Greater Asheville Regional Airport Authority Regular Meeting
Friday, September 20, 2024, 8:30 a.m.
Council Chambers at Fletcher Town Hall
300 Old Cane Creek Road, Fletcher, NC 28732

Approval of Construction Contract Change Order No. 4 with Kokolakis Contracting for the Air Traffic Control Tower and Associated Facilities Project

Change Order

PROJECT: <i>(Name and address)</i> Greater Asheville Regional Airport Air Traffic Control Tower (ATCT) and Associated Facilities Project 146 Westfeldt Road Mills River, NC 28732	CONTRACT INFORMATION: Contract For: Construction Date: December 05, 2022	CHANGE ORDER INFORMATION: Change Order Number: 04 Date: 09/11/2024
OWNER: <i>(Name and address)</i> Greater Asheville Regional Airport Authority 61 Terminal Drive, Suite 1 Fletcher, NC 28732	ARCHITECT: <i>(Name and address)</i> Pond and Company 3500 Parkway Lane, Suite 500 Peachtree Corners, GA 30092	CONTRACTOR: <i>(Name and address)</i> Kokolakis Contracting, Inc. 202 E. Center Street Tarpon Springs, FL 34689

SUBJECT: COR#17r4 – ASI 006 Precast Louver Modifications – Time Impacts

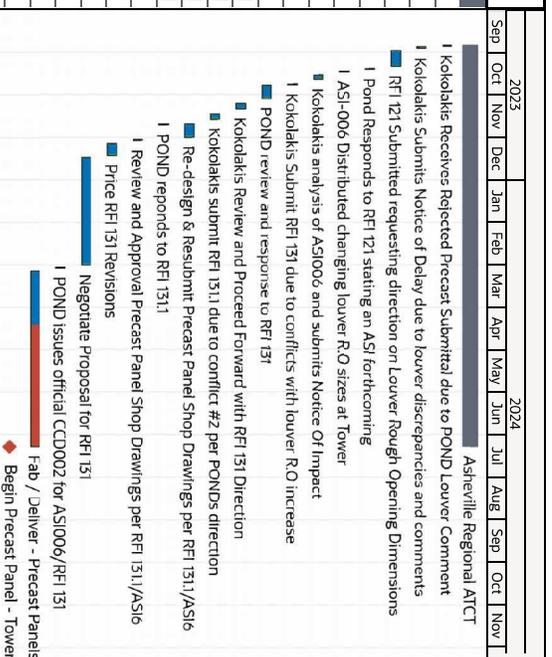
Attached is the revised cost proposal No. 017r4 for the delay in fabrication of the tower precast panels resulting from the increased louver openings which necessitated structural re-design of the panels.

This proposal has been revised pursuant to the change review meeting held on 7/21/24 in the amount of **\$281,627.00 and includes a 194 Calendar Day time extension request comprised of 65 compensable and 129 concurrent delay days.**

- Total Requested Impact - 288 Calendar Days**
- 9/25/23 through 7/9/24
 - Stem Wall Remediation - 2/23/24 through 4/19/24 - 56 Calendar Day of Concurrent Impact
 - 288 Calendar Days less 56 Calendar - 232 Calendar Days of compensable impacts requested
